Notice of specification change of MCCB & ELCB

Before	After
<p>Sanple)NF800-SEW 3P</p>  <p>Setting dial indication</p>	<p>Setting dial indication The indication becomes darker.</p>

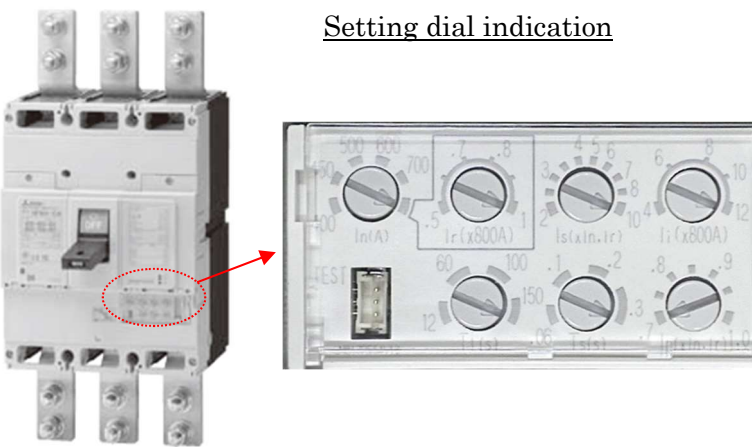
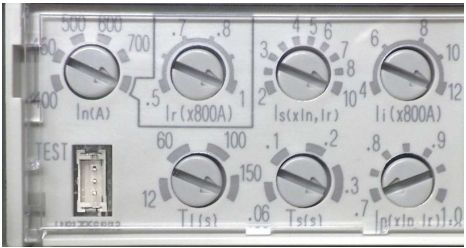
Improve visibility of setting dial indication on the surface of the body cover.

There is no change in the displayed content.
